From: Gregg Peel [gregg.peel@tianma-nlt.com]
Sent: Friday, March 27, 2015 11:07 AM
To: Pcn System; Sean Nantel; Joanne Shapiro-Libman; Ryan Robidoux; Cormac McGrath
Cc: Elaine DeLong; Gregg Peel
Subject: PCN# 41807- PCN NLT-PP-5125: 15.0" NLB 01L-01 - Packaging Change (Revised)
Attachments: PCN NLT-PP-5125_(Revised_5065)_NLB150XG_Packing_change.pdf

NLT Product Change Notice
PCN Tracking Number: NLT-PP-5125
(Revised from NLT-PP-5065)

15.0" XGA NLB150XG01L-01

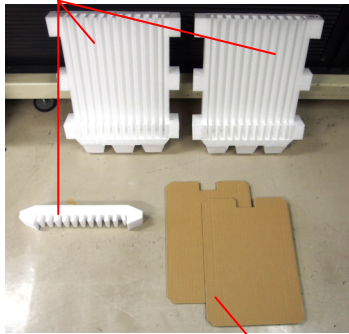
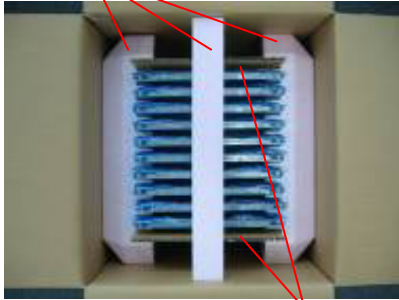
5. Inner pad and partition board

Inner pad and Partition board in the product packing box will be changed.

Current	After change
Inner pad and Partition board	<p>Inner pad</p>  <p>Partition board</p>	<p>Inner pad</p>  <p>Partition board</p>
Overview	<p>Inner pad</p>  <p>Partition board</p>	<p>Inner pad</p>  <p>Partition board</p>
